DRAWINGS AND DESCRIPTION OF PROPOSED CHANGES

TOTTENHAM HALE CENTRE ISLAND SITES

PROPOSED L01 FLOOR PLAN

3.4 BUILDING 1 UPPER FLOORS - FIRST FLOOR

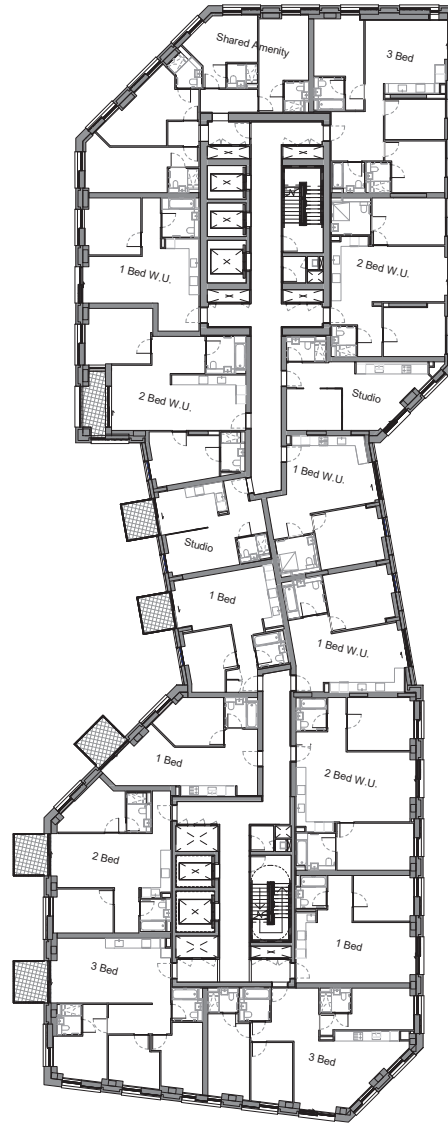
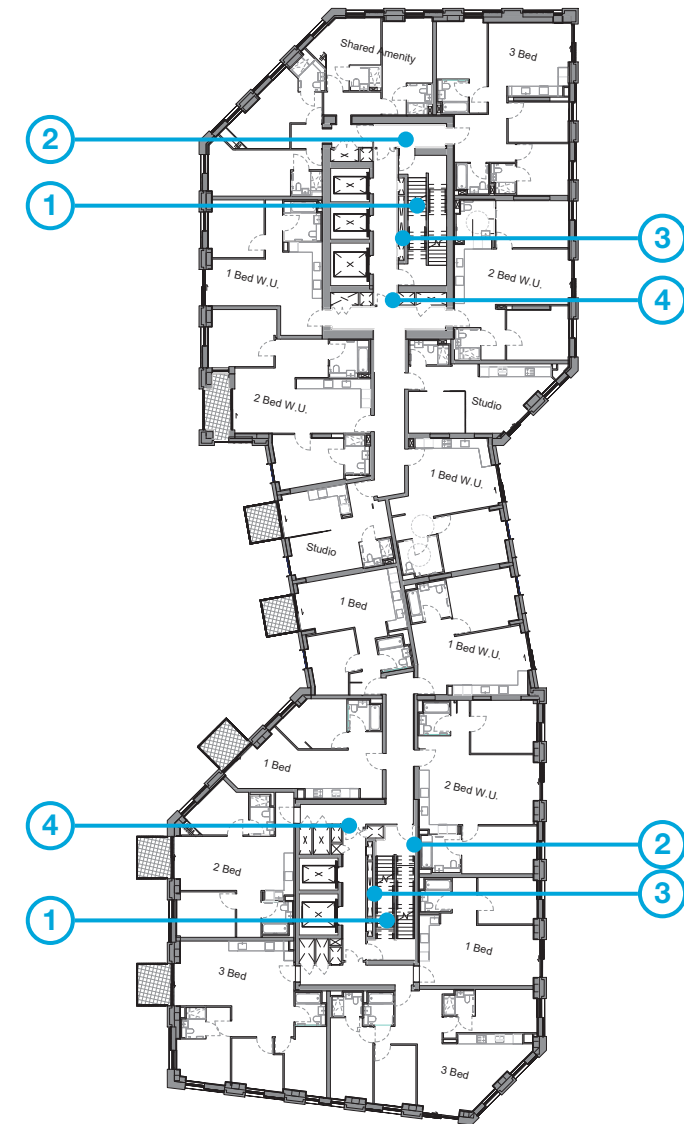
1. A second fire escape stair has been added between ground floor to upper levels.
2. Due to the addition of the second stair, the position of the access to the stairs has changed to resolve level changes across all floors.
3. Service risers have been relocated within the core following the addition of the second staircase.
4. Additional doors have been added within the communal corridors to comply with the latest fire strategy.
